# **FMI ADMINISTRATIVE INFORMATION FMI No: 67602**

**FMI Title : Magnet Interface Replacement and MFO1 M4 Patch Installation  
for Signa Ovation System**

Bug fix and improvement of software quality for MFO M4 Software

**DIP SW SETTING OF NEW MAGNET INTERFACE UNIT  
ILLUSTRATION 1**

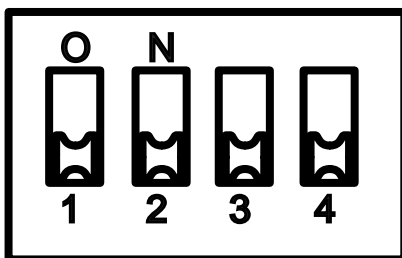
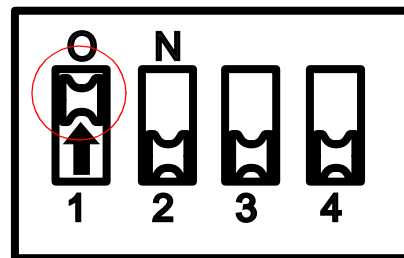
For new magnet interface unit (2254366-2), provide a bank of 4 dip switches including a function to select logic of OpenSpeed and Ovation, and this unit is keeping compatibility of OpenSpeed and Ovation by dip switch setting. Differential of logic is a signal condition for collision only.

- 1. Before installing the new unit, open the top cover of the New Magnet I/F unit by removing the 10 screws.
- 2. Slide switch 1 to ON position. Switch 2, 3 and 4 are OFF position.
- 3. Restore top cover of the magnet I/F unit with 10 screws.

**Switch 1 should be in the ON position,  
2,3,4 are in the OFF position.**
